Subject: **Palo Verde Nuclear Generating Station Unit 3
Docket No. STN 50-530
Renewed Operating License No. NPF-74
Response to Request for Additional Information - Relief Request 63 -
Unit 3 Impractical Examinations for the Third 10-Year Inservice
Inspection Interval**

**Response to Request for Additional Information - Relief Request 63 - Unit 3
Impractical Examinations for the Third 10-Year Inservice Inspection Interval**

Figure 1: Weld 42-100 and 42-101 Mock-up Block

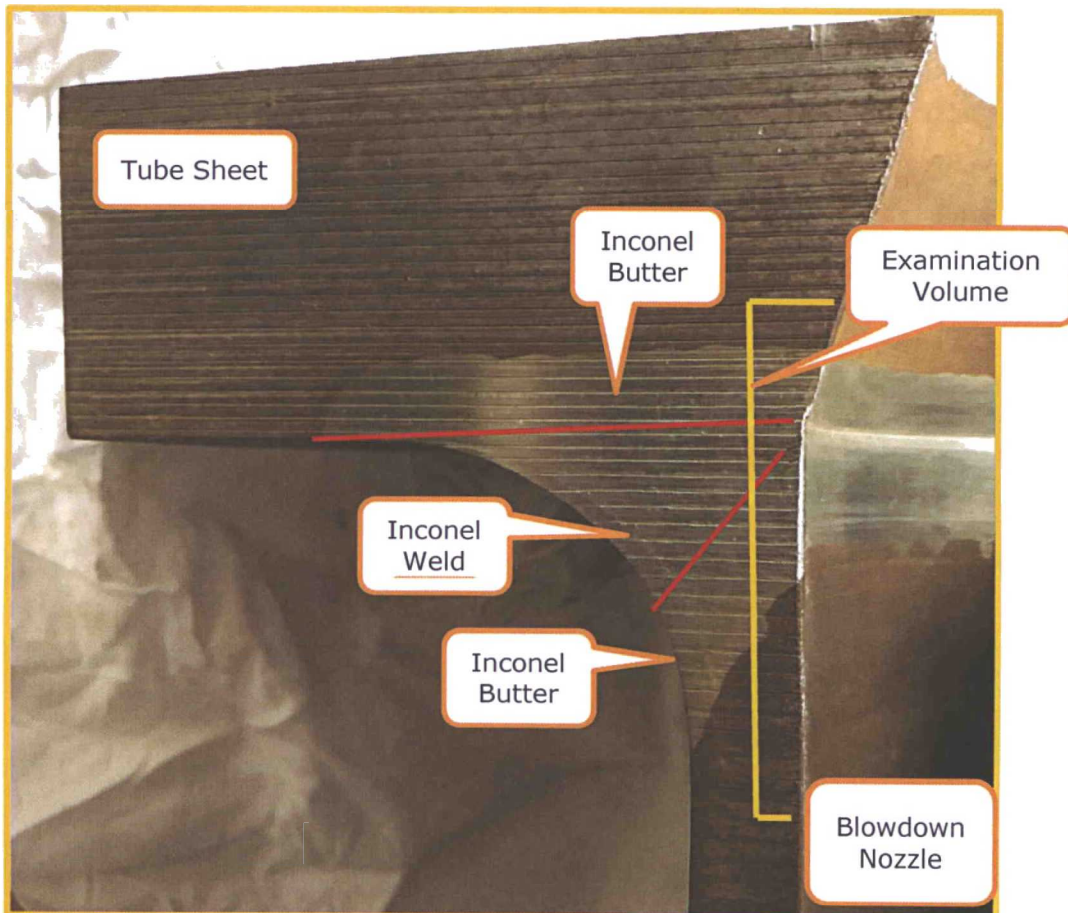
Table 1 states that ultrasonic testing (UT) examinations were not performed on welds 42-100 and 42-101 because the UT equipment could not be calibrated due to "weld materials and configurations." Please describe the efforts taken to calibrate the equipment. Please describe the specific aspects of the weld materials and configurations that prevented the calibration of the UT equipment.

During the Unit 3 thirteenth refueling (3R13) outage, the steam generators were replaced. A mock-up shown in Figure 1 was fabricated by the steam generator vendor for the Unit 3 blowdown nozzle weld configuration that utilized an Inconel attachment weld configuration. Figure 2 shows a cross section of the blowdown nozzle weld, illustrating the carbon steel tube sheet, Inconel butter, Inconel attachment weld and carbon steel blowdown nozzle. For ultrasonic preservice examinations of the replacement steam generators blowdown nozzles, efforts were made to calibrate utilizing the mock-up but examinations were documented as best effort examinations.

During the third interval, multiple attempts were made to validate an ultrasonic technique utilizing the vendor provided weld mock-up. Ultrasonic examiners utilized a variety of shear wave transducers and longitude wave transducers and a proper validation was not achieved on the weld mock-up for welds 42-100 and 42-101. The nozzle mock-up was sent to the North Carolina Electric Power Research Institute Nondestructive Evaluation Facility to evaluate inspection methods including the use of state-of-the-art phased array ultrasonic techniques. Attempts at providing an ultrasonic inspection technique for the configuration were unsuccessful. The difficulty of examination on the steam generator blowdown nozzle weld configuration is a combination of geometric and material issues. Geometric issues exist due to the extended weld volume due to the Inconel butter on the tube sheet and blowdown nozzle as shown in Figure 2. Material issues present examination difficulties as the Inconel butter and Inconel weld complicate pulse echo ultrasonic exam techniques attempted due to the high attenuation and issues with beam redirect that occur in austenitic materials and dissimilar metal weld configurations.

Figure 3: Unit 2 Blowdown Nozzle to Shell Weld

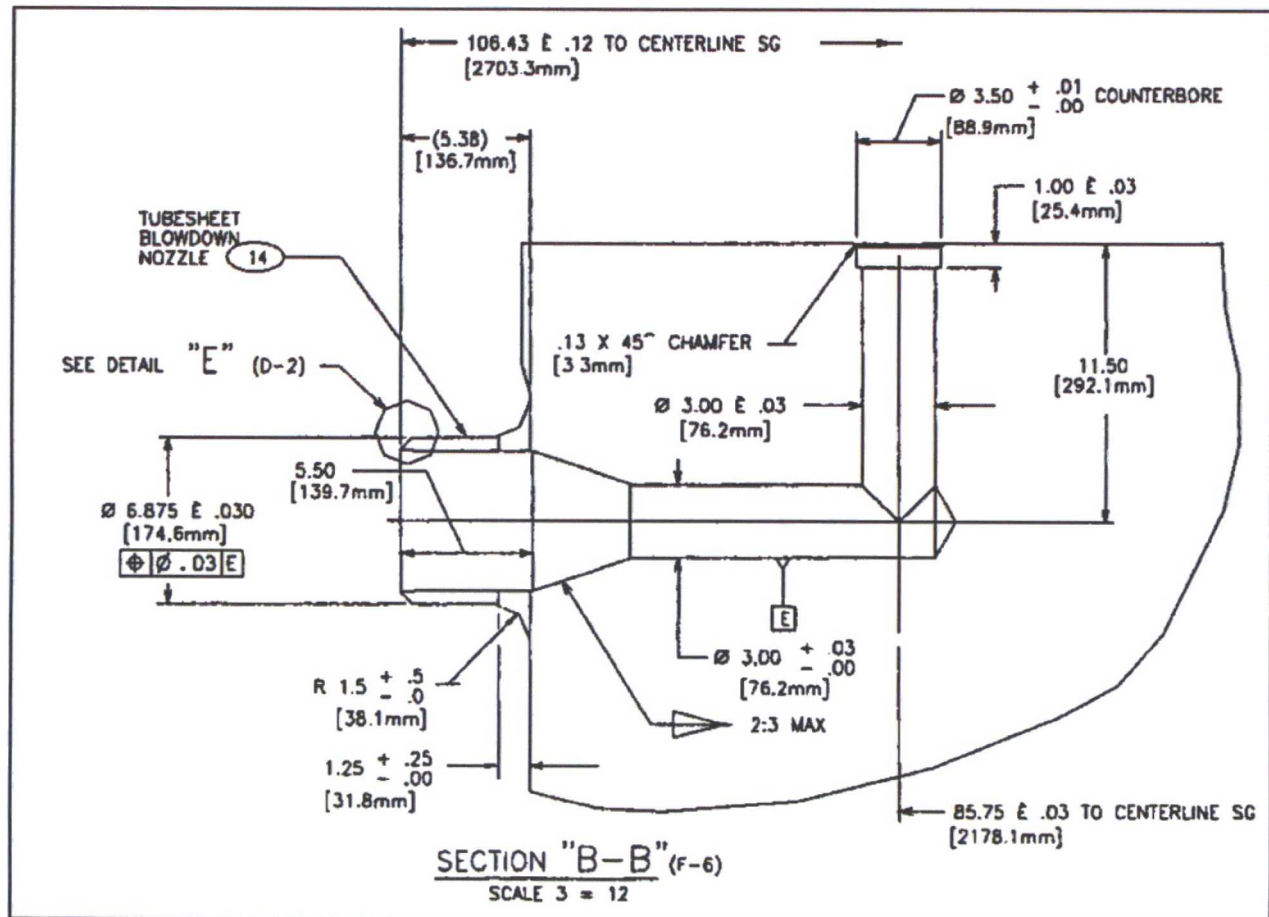
Please identify any other steam generators operated by APS with similar blowdown nozzle configurations to 42-100 and 42-101. If UT examinations have been successfully performed on locations comparable to 42-100 and 42-101, please describe the differences that permitted UT examination and examination results.

The Unit 2 steam generators have carbon steel blowdown nozzles and welds (Figure 3) that were successfully examined in the third ISI interval. The Unit 2 nozzle configuration provides a more accessible examination volume and favorable materials for ultrasonic examinations.

Figure 4 – Selected Stress-Lines

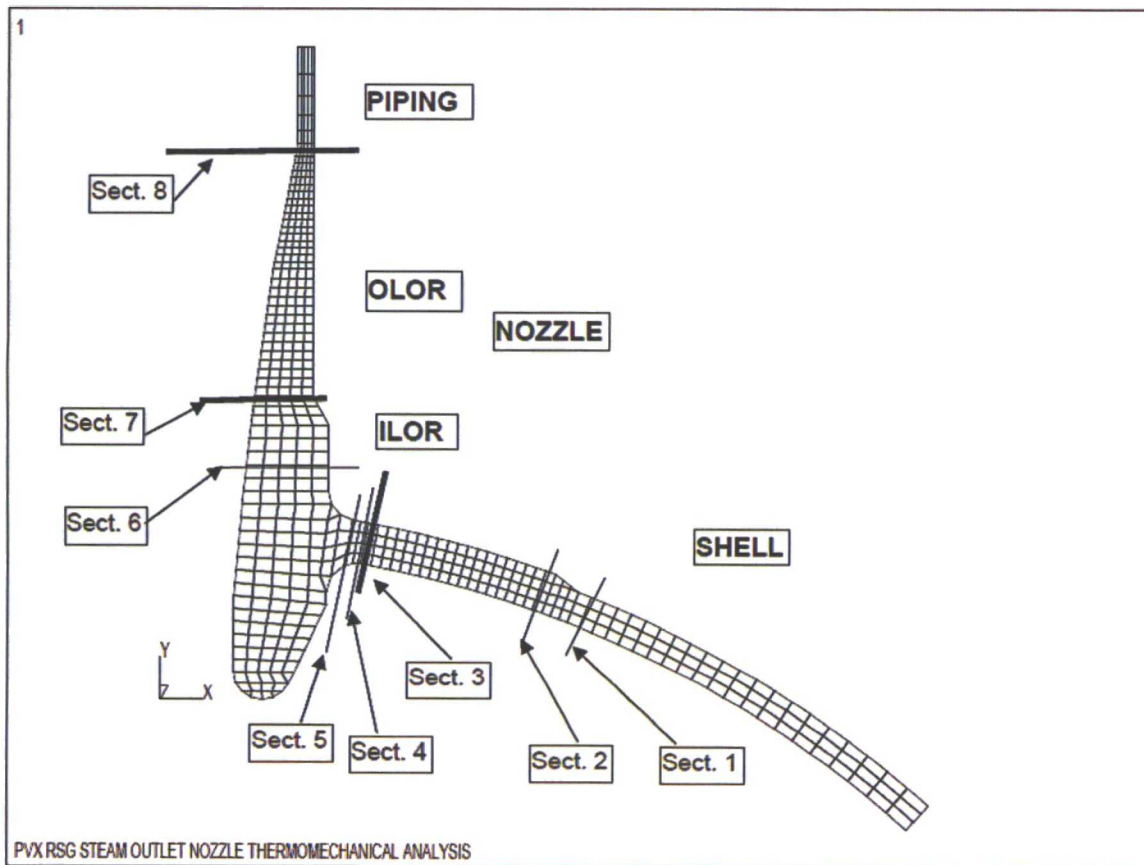
Please provide a description, assumptions, and results of the "Structural and fatigue analysis of the steam outlet nozzle" (ANSALDO PV-RPM-13-000012, Rev.2).

The analyses presented in reference 1 demonstrate that the steam outlet nozzles of the steam generators satisfy the requirements of the ASME Code Section III, Class 1, in the Design Level A/B, Level D and Test conditions for primary stresses caused by pressure and external loads and secondary stresses caused by plant thermal operating transients. In addition, the nozzles were also analyzed for the effects of fatigue damage and are determined to be acceptable.

The results are summarized in tables 1, 2 and figure 4, where the bounding ratios between calculated values and allowable limits are shown.
